APPLICATION FOR PERMIT TO DRILL OR DEEPEN

XTO Energy Inc.

XTO Energy Inc.
Ute Indians A #37
Proposed Drilling Procedure
October 4, 2002

XTO Energy Inc.
Tribal Lease: 14-20-604-62
Well: Ute Indians A #37
Location: 1900' FSL & 1690' FEL
Sec. 34, T. 32 N., R. 14 W.
San Juan County, New Mexico

BOP SCHEMATIC FOR DRILLING OPERATIONS CLASS 1 (2M) NORMAL PRESSURE

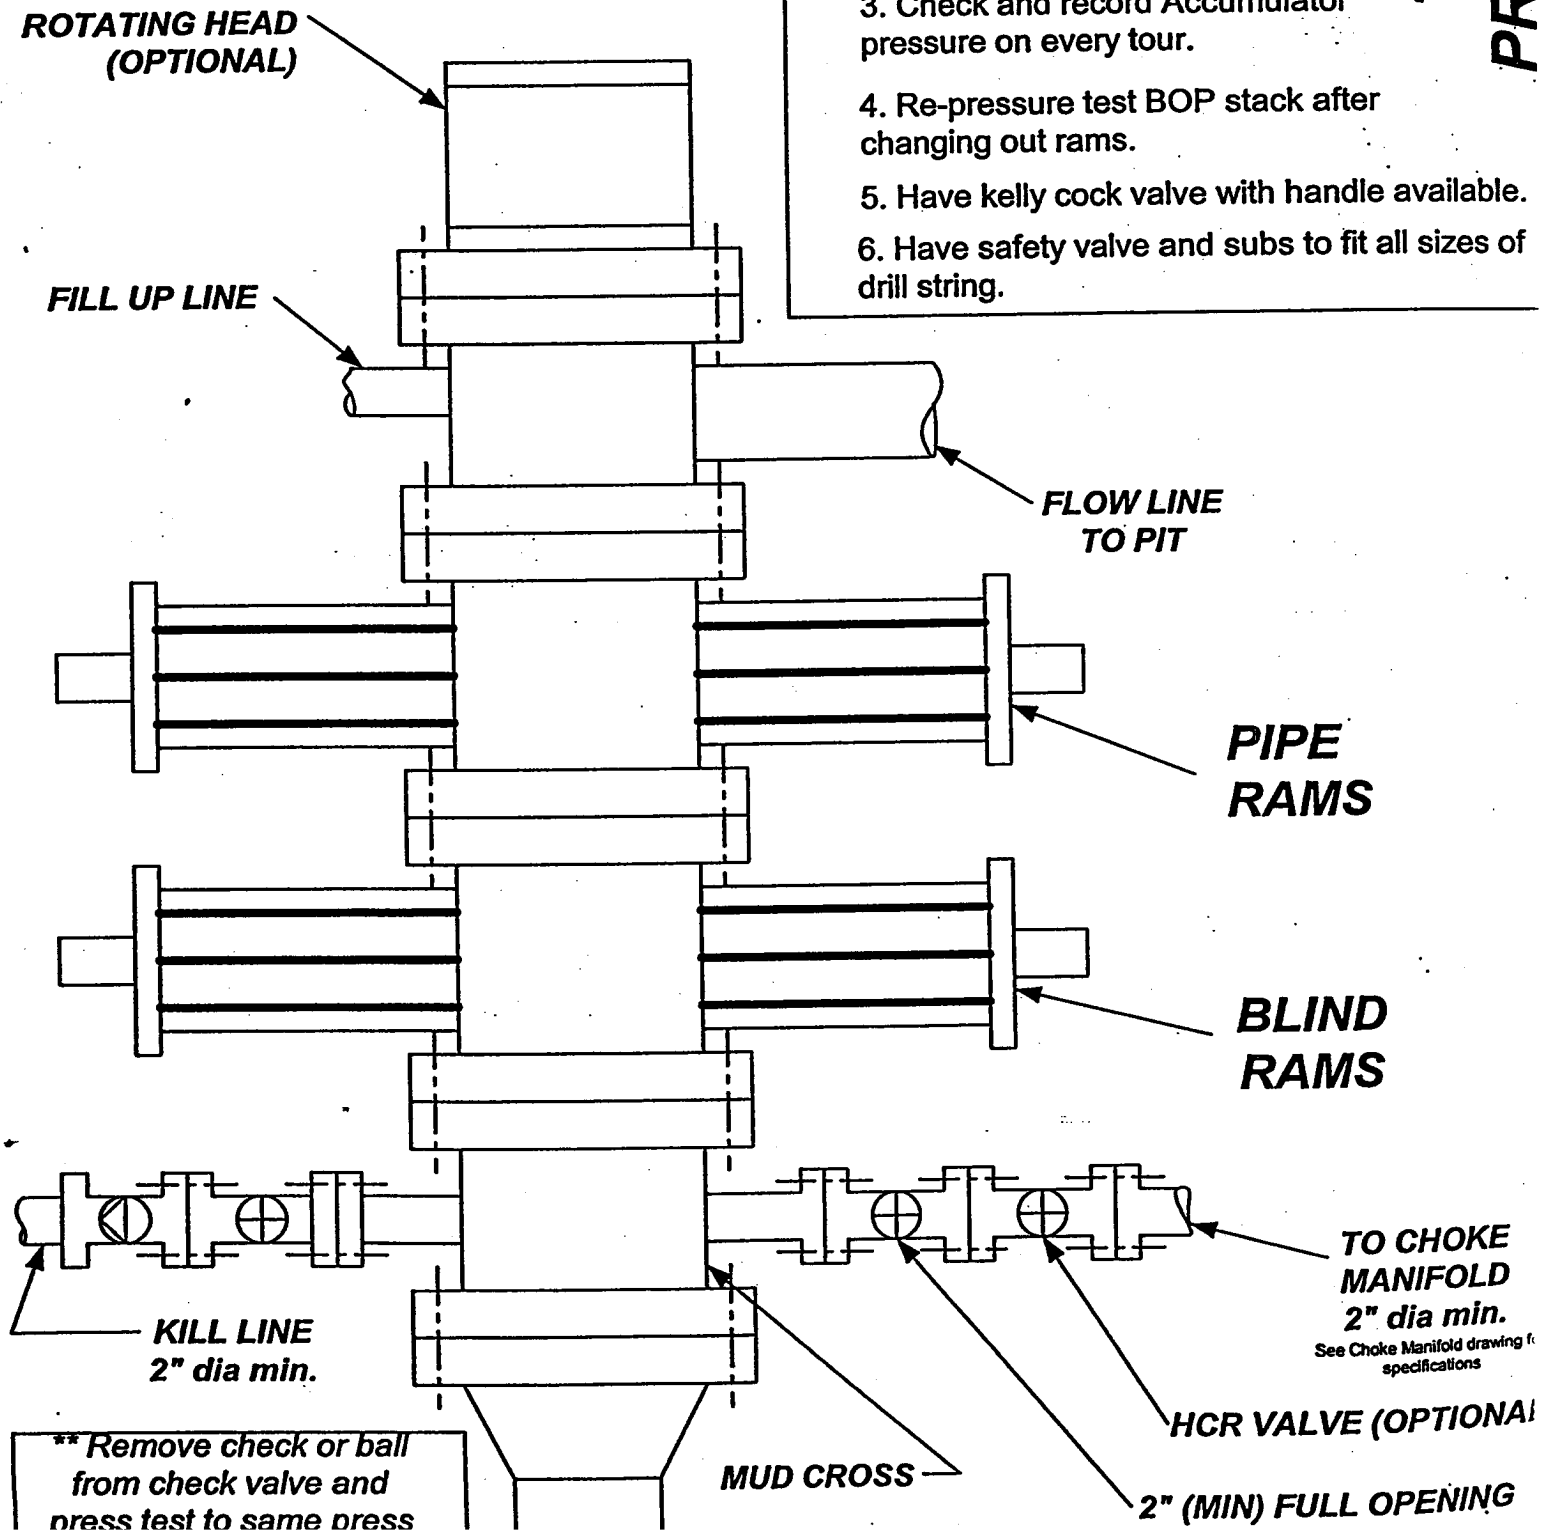
6. All BOP tests will be performed with a test plug in place. BOP will be tested to full stack working pressure and annular preventer to 50% maximum stack working pressure. All accumulators will be function tested as per Onshore Order #2. All 2M or greater systems require **adjustable** chokes as per Onshore Order #2.
